NEEDHAM PLANNING BOARD
Thursday July 7, 2022
7:00 p.m.

7:15 p.m. Major Project Site Plan Special Permit No. 2022-02: 557 Highland, LLC, an affiliate of The Bulfinch Companies, Inc., 116 Huntington Avenue, Suite 600, Boston, MA, Petitioner. (Property located at 557 Highland Avenue, Needham, Massachusetts). Regarding proposal to redevelop the Property with approximately 496,694 square feet of office, laboratory and research and development uses (see legal notice and application for more details). *Please note: this hearing has been continued from the June 7, 2022 meeting of the Planning Board.*

Figure 2
Site Plan & Circulation

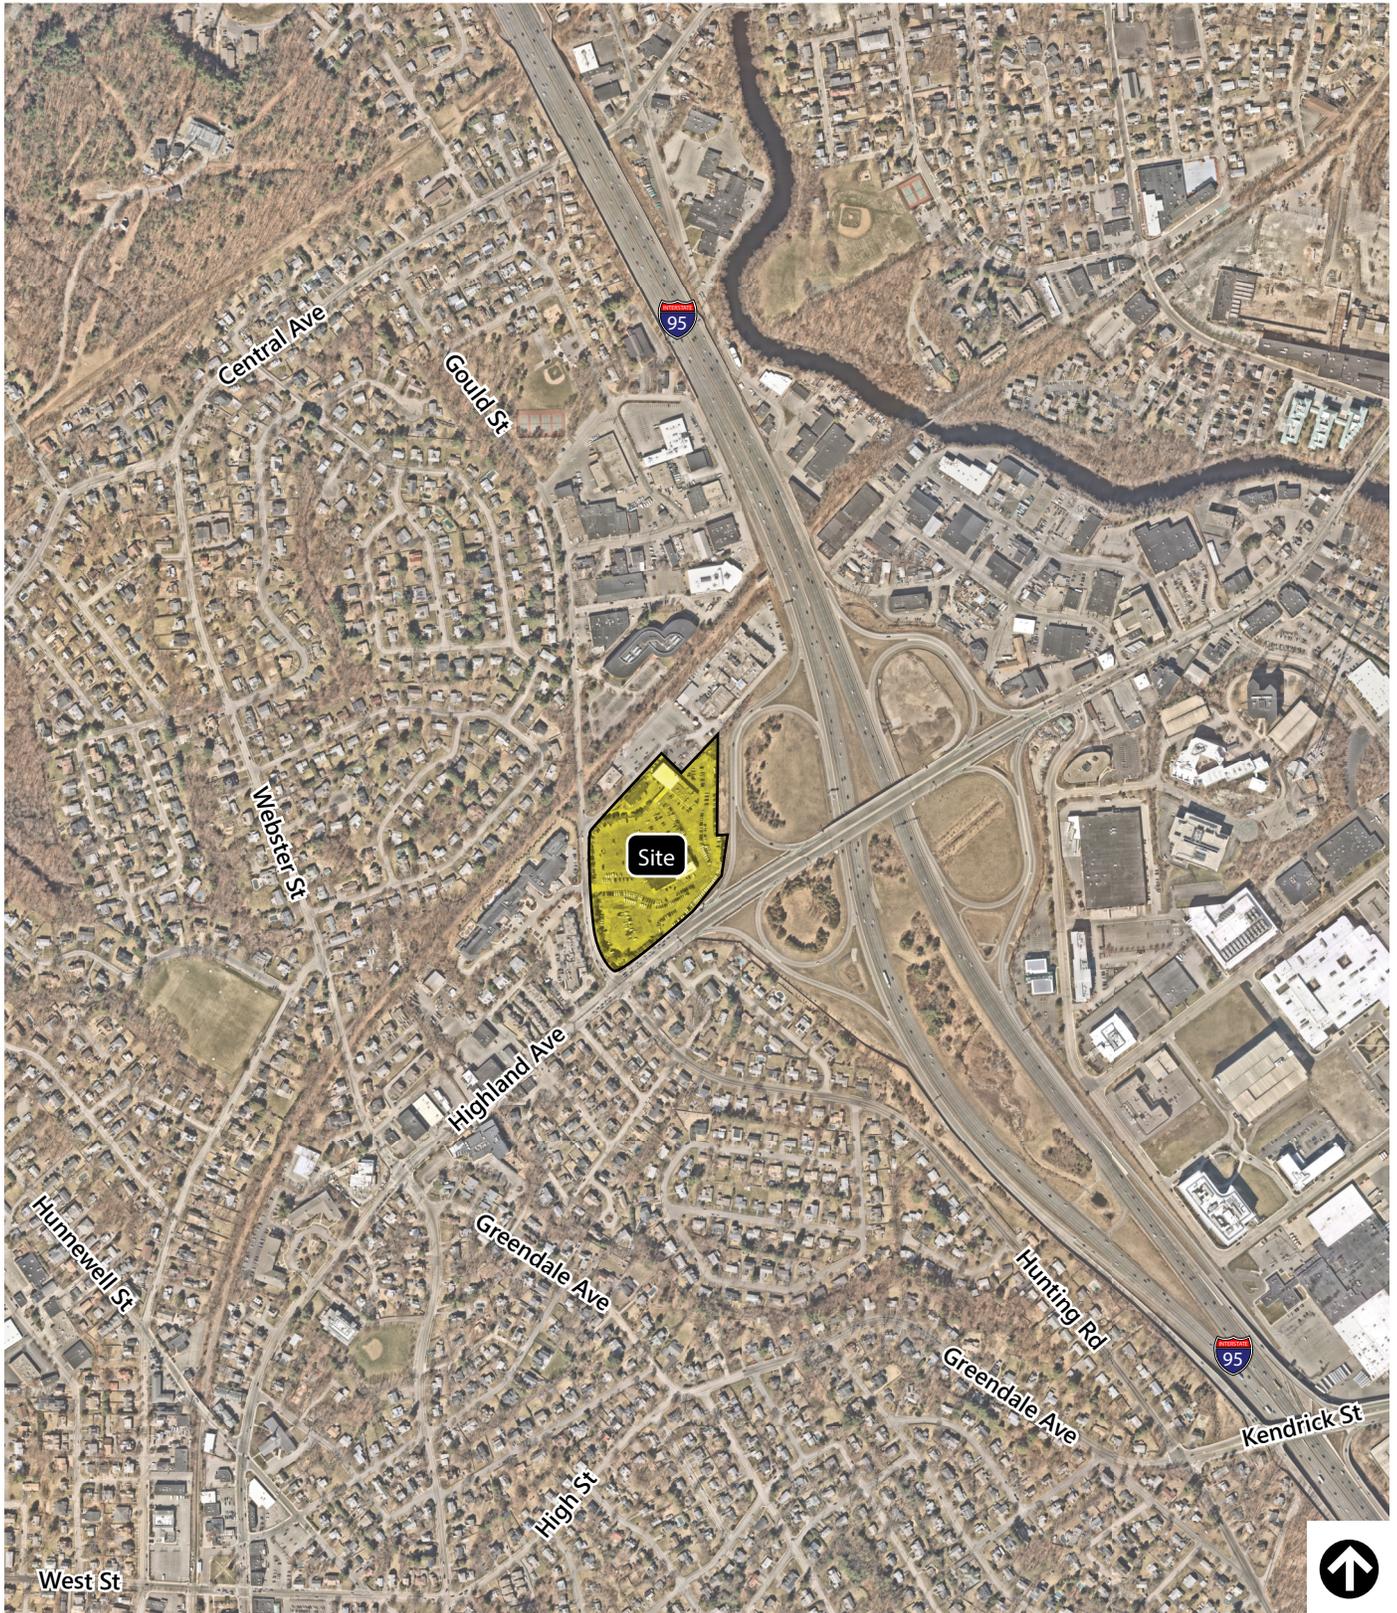
29. Figure 2 of the TIAS provides a site plan depicting the proposed layout and traffic circulation on the site. The plan appears to indicate that a loading/unloading area will be provided at the front of the site between Buildings A and B. This loading area is located in close proximity of the signalized intersection of the main site driveway and Gould Street. Vehicles, particularly trucks, stopped in this area could cause a back up of traffic into Gould Street. The Applicant should consider modifications to the site plan that provide a clear separation of loading/unloading areas and through traffic access to the parking fields to ensure traffic does not back up onto Gould Street. In addition, the Applicant should consider limiting hours of deliveries to the site, as a condition of approval, to avoid deliveries occurring between 7:00 AM and 9:00 AM when a high volume of traffic may be entering the site from Gould Street to access the parking garage.

31. The site plan included in Figure 2 does not depict any pedestrian connections between the proposed surface parking lot and the buildings. The Applicant should modify the site plan to provide fully accessible pedestrian routes between the surface parking lot and both buildings, as well as to the pedestrian loops around the site.

Applicant Response: The Site driveway will be designed to accommodate the queues waiting at the traffic signal at Gould Street. The garage entrance closest to the traffic signal will only provide access to the loading dock, which will be designed so that loading and unloading vehicles will not block the circulating Site roadway. The development is not expected to receive many deliveries during the weekday evening peak hour, but if a delivery truck needs to leave the loading dock and the queue at the signal extends past the loading dock, the delivery truck will be able to turn right onto the circulating Site roadway and exit the Site via TV Place. The entrances to the underground parking area and the free-standing parking garage are around the corner and more than 200 feet away from the signal, providing sufficient room for vehicles to queue without spilling back into the main parking areas. While a queue of 200 feet may extend past the pick-up/drop-off area, that should not be an operational issue as the pick-up/drop-off area will be located on the other side of the circulating Site roadway. Drivers using the pick-up/drop-off area are expected to enter the Site at the signalized driveway and exit the Site at TV Place, traveling in a counterclockwise direction.

Figure 13

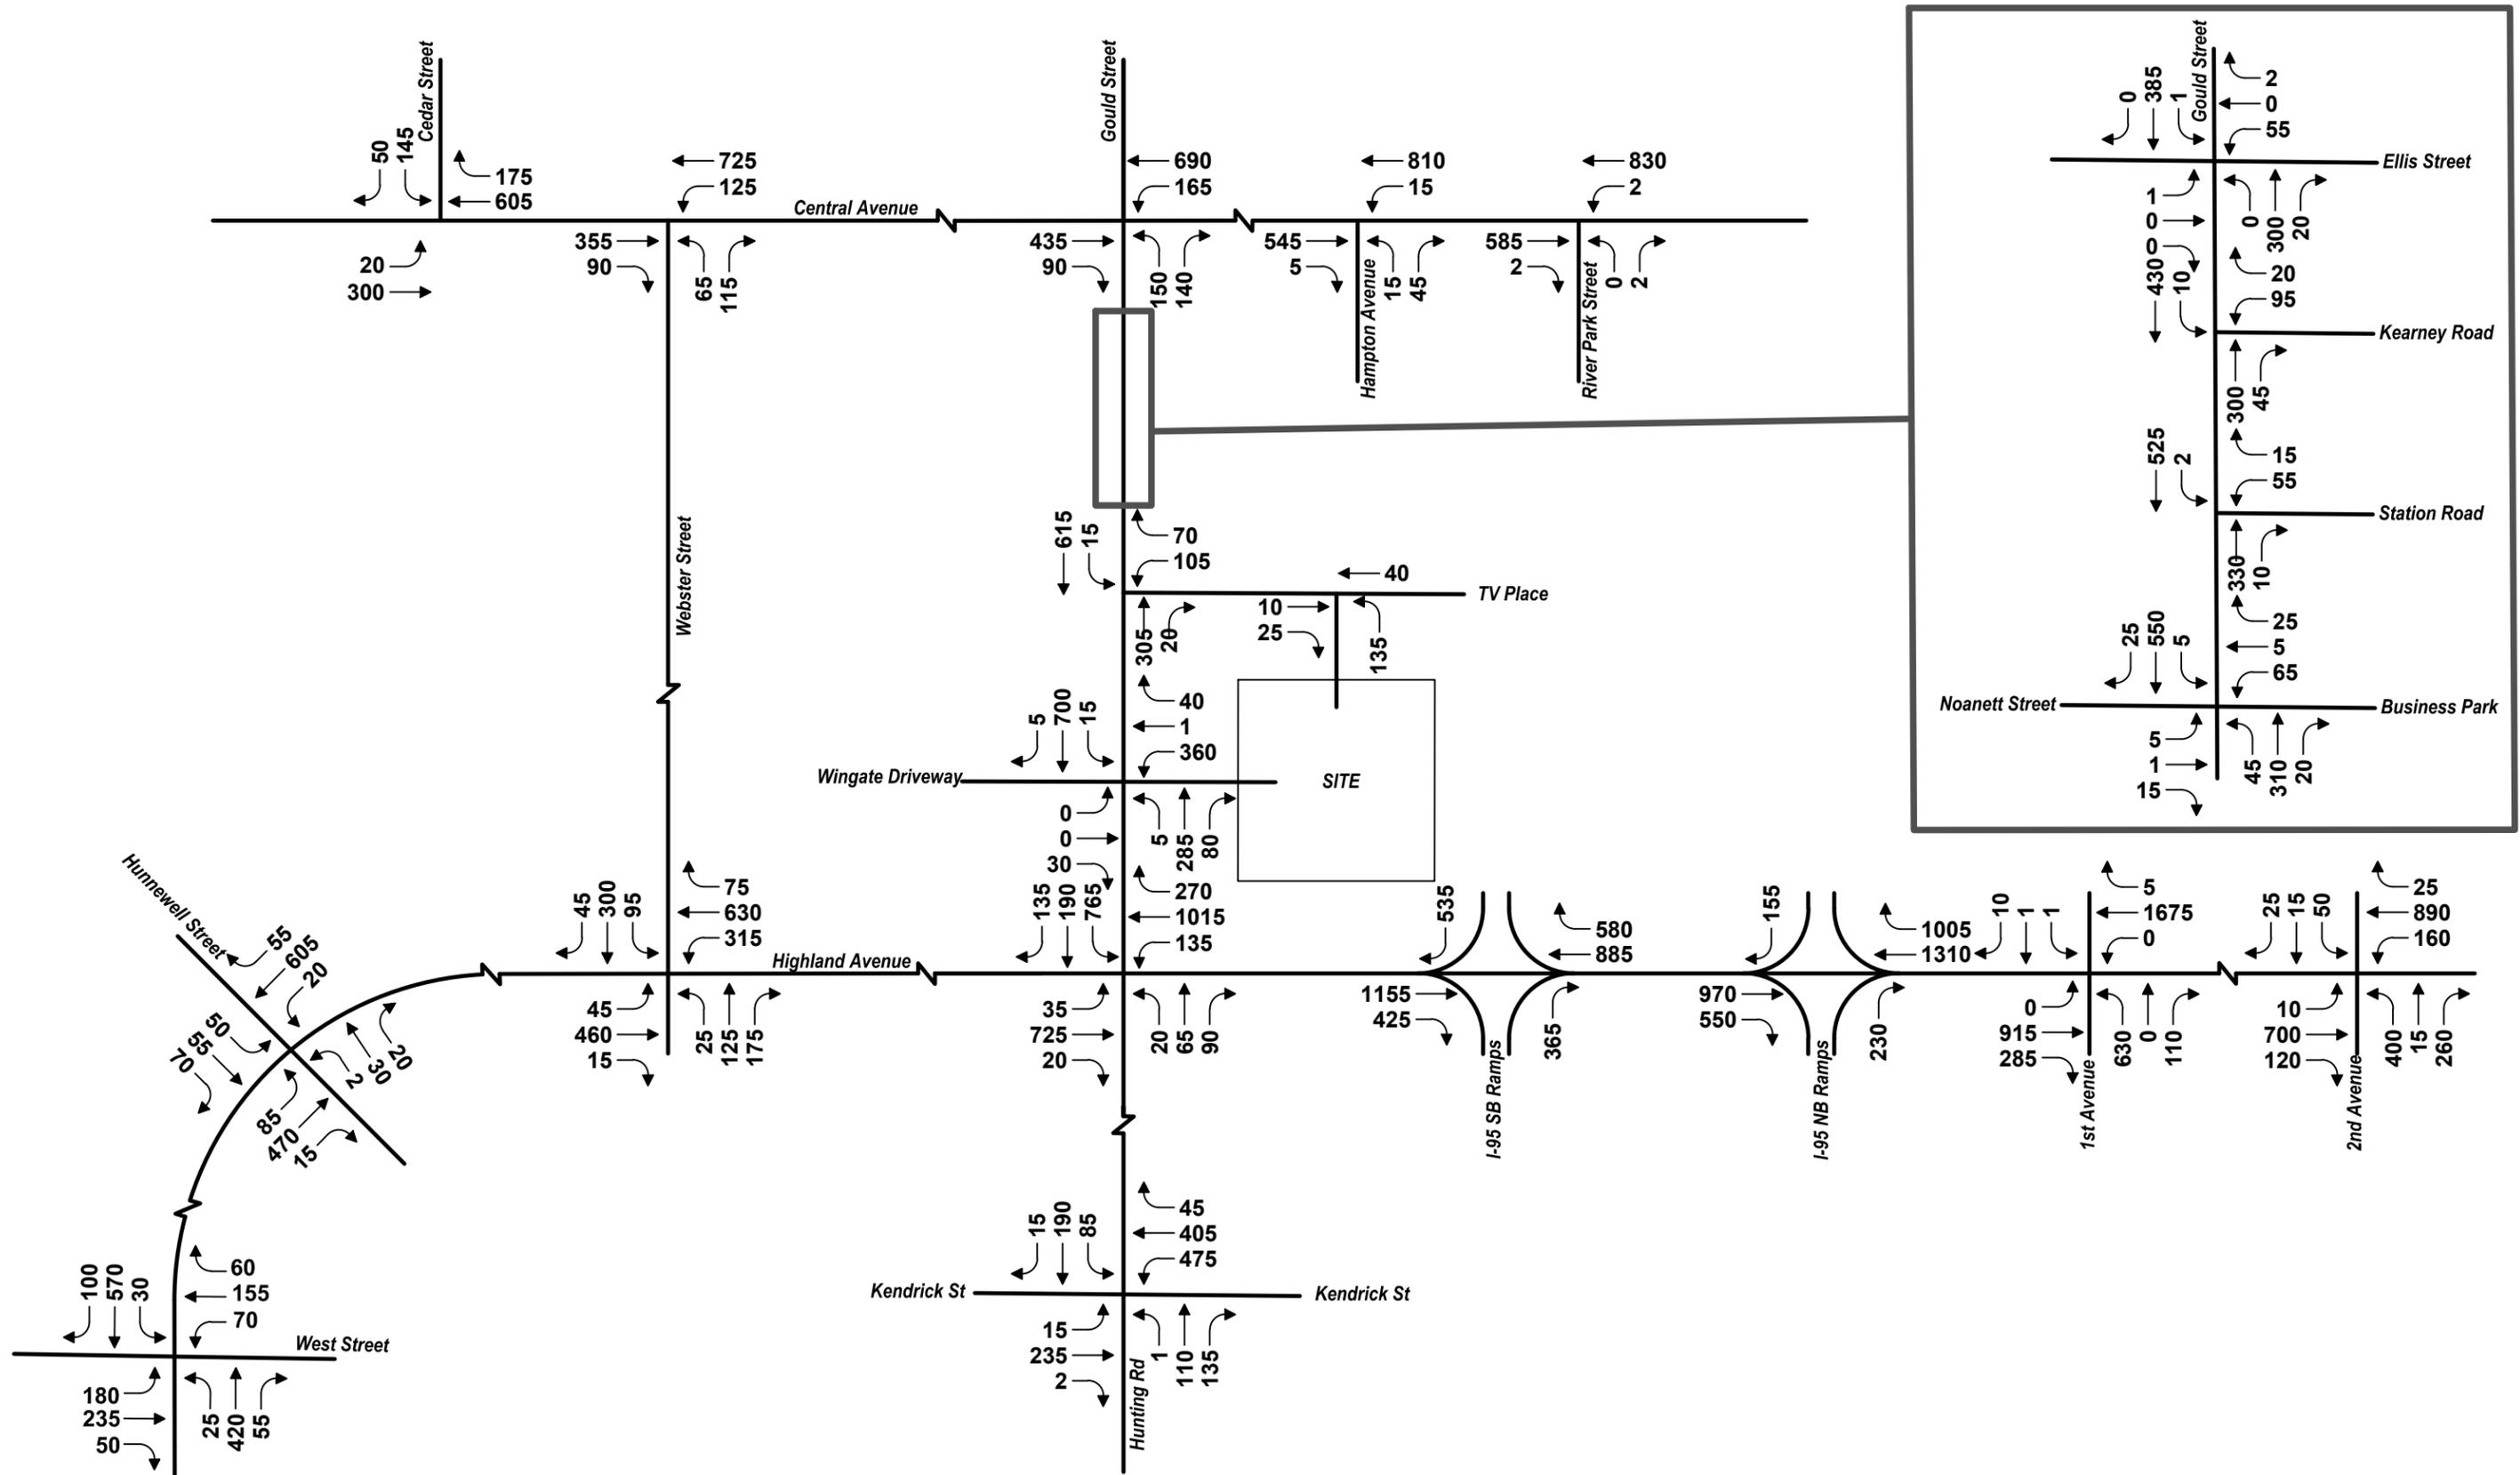
12. As stated by the Applicant in the report, the pass-by-trips include trips for the retail uses already traveling on the roadway network under Existing Conditions. However, these trips still enter and exit the project site. They should only be adjusted for adjacent roadways, but not for entering and exiting the project site. **Nitsch requests the Applicant provide update Table 5, as well as Figures 11 through 14. Also, the capacity analysis for Build Condition may need to be revised.**

Figures 13 and 14 presented in the TIA illustrate the 2029 Build Conditions peak hour traffic volumes. The traffic volumes include all Project-generated trips entering and exiting the Project Site, including existing trips generated by the previous uses and the pass-by trips. The intersection capacity analyses for the Build Condition are based on the traffic volumes presented in Figure 13 and 14 and include the pass-by trips. Therefore, the intersection capacity analyses for the Build Condition do not need to be revised, as they already include the pass-by trips entering and exiting the Project Site.

Figure 15 provides an illustration of the proposed intersection improvement concept. A summary of the traffic operations with the proposed mitigation in place is provided in the following section.

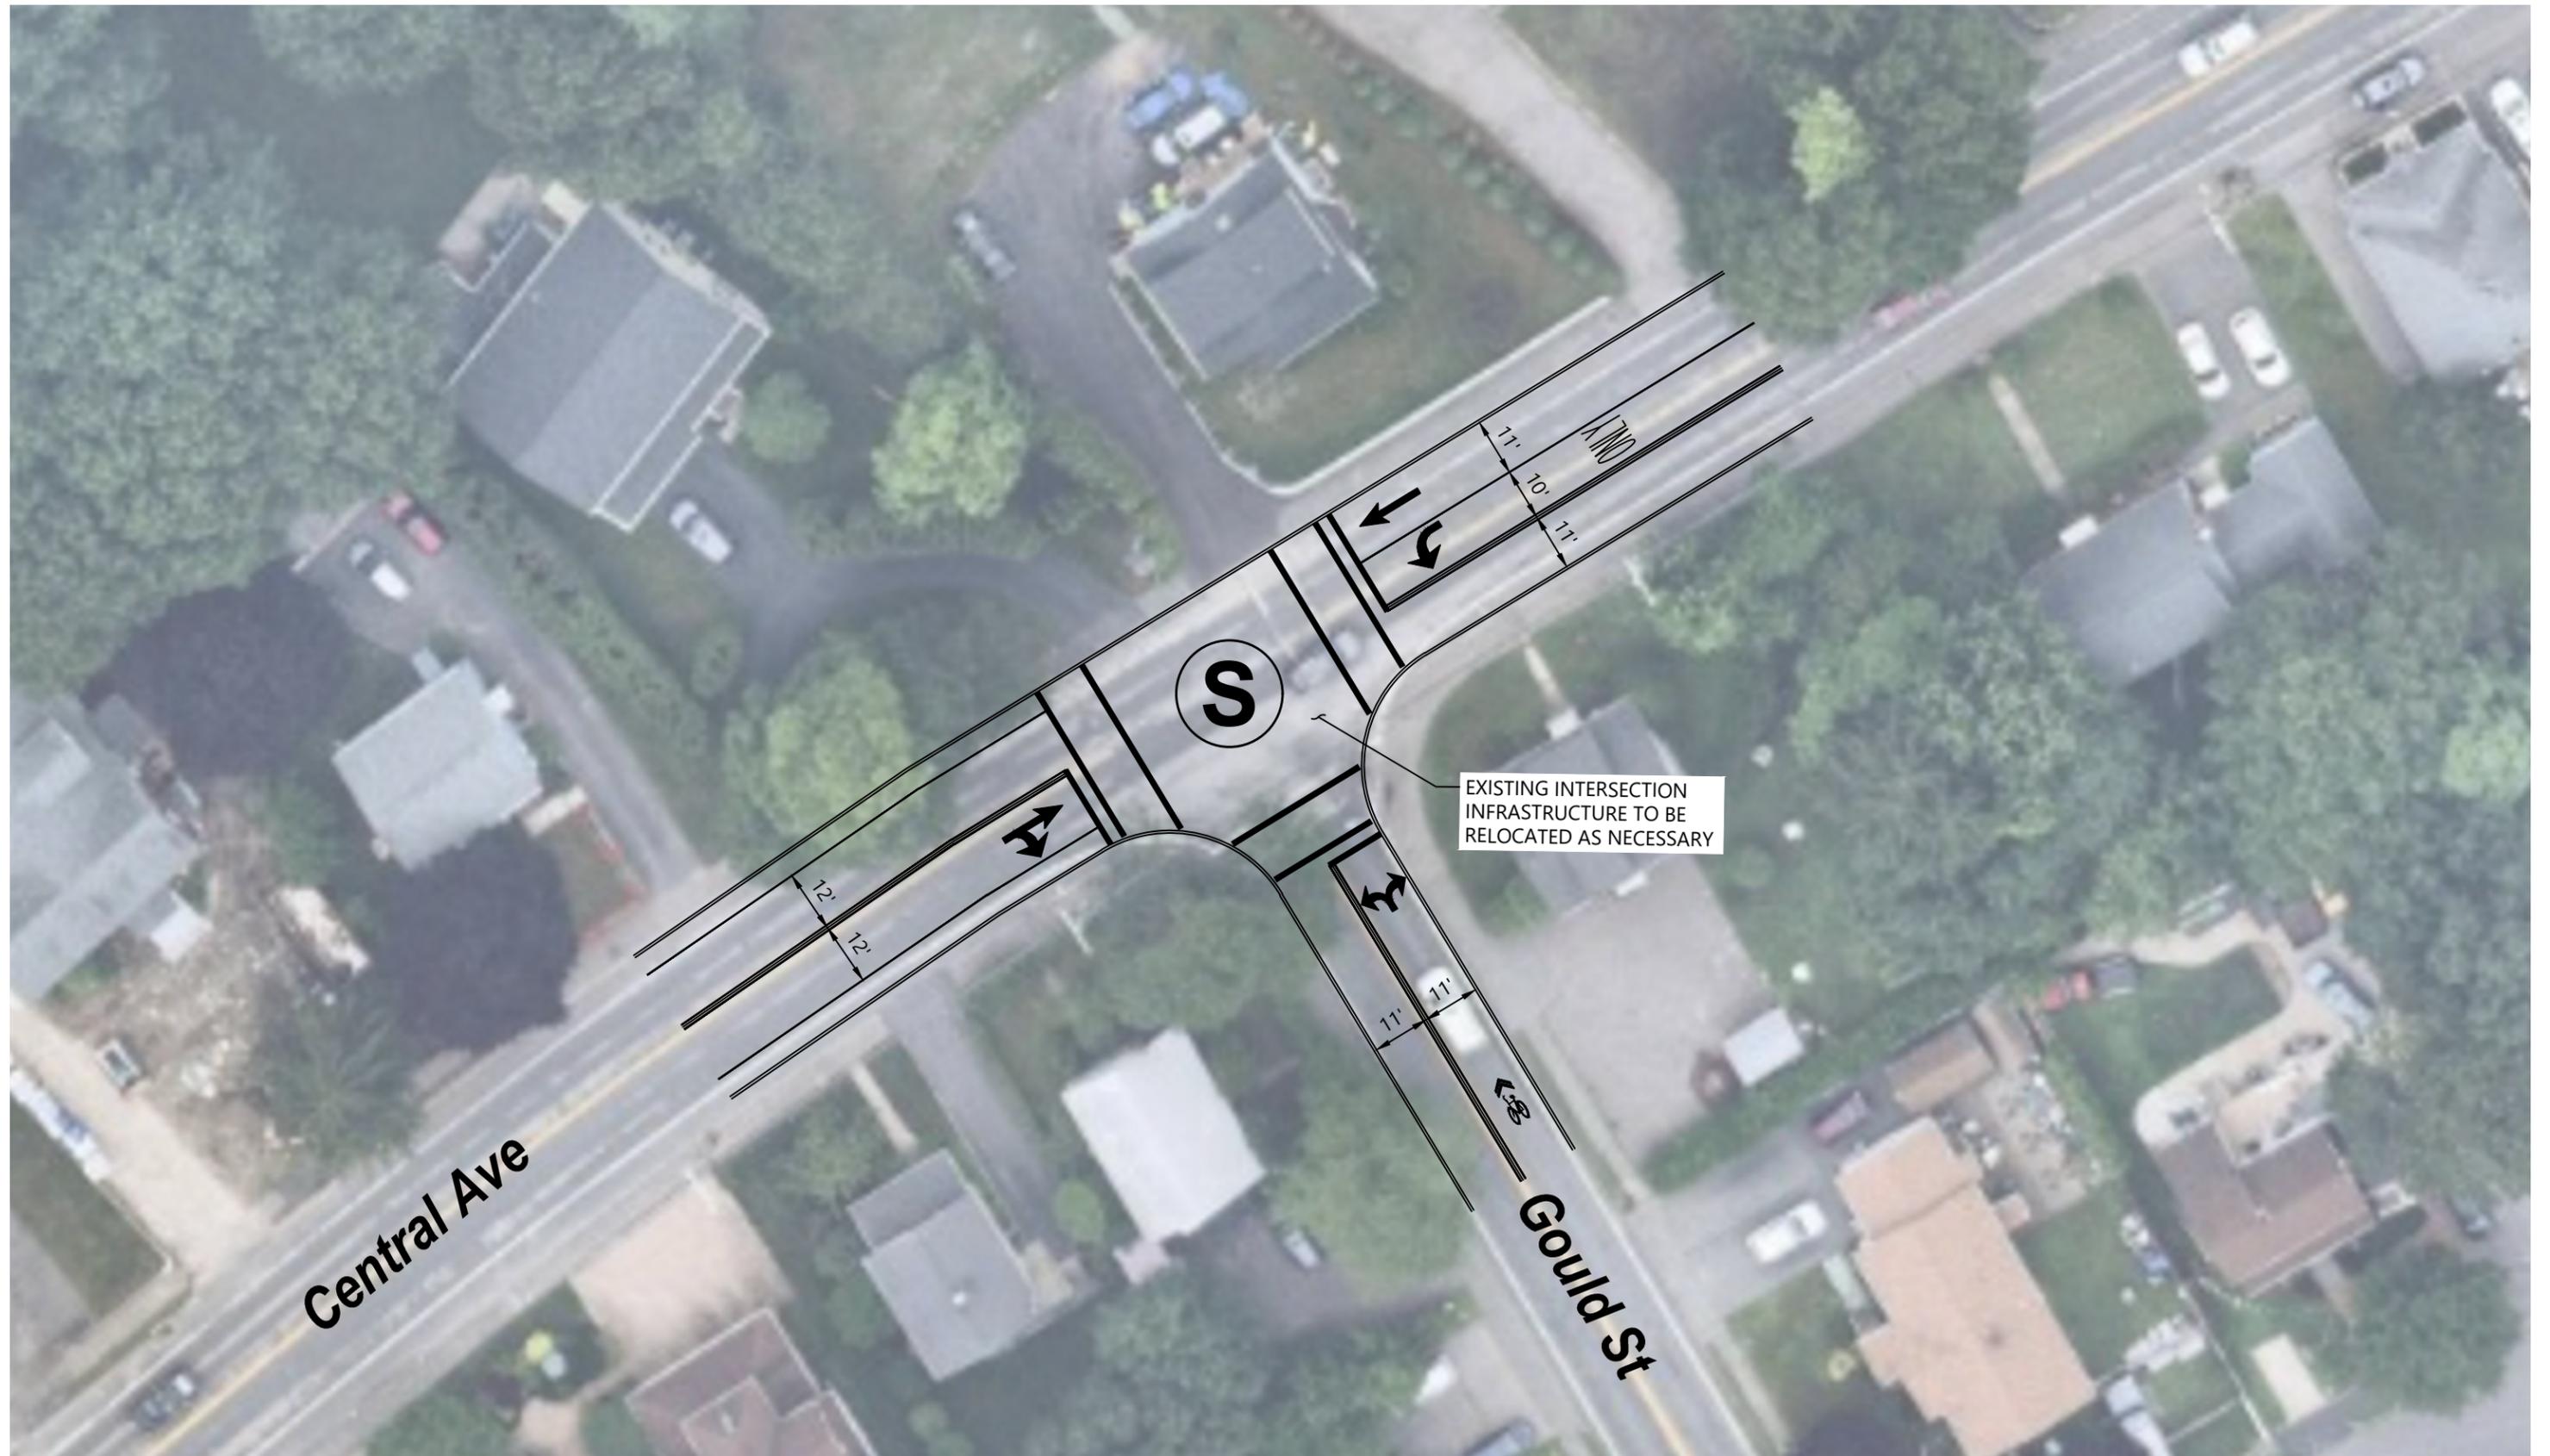
20. Figure 15 of the TIAS depicts improvements to be constructed at the Central Avenue / Gould Street intersection as mitigation for the project, which include restriping of Central Avenue to provide a westbound left-turn lane and installation of a fully-actuated traffic signal. The proposed signal equipment is not depicted on the plans. The Applicant should obtain survey information at this location to verify whether the proposed improvements can be constructed within the publicly-available right-of-way and whether any easements will
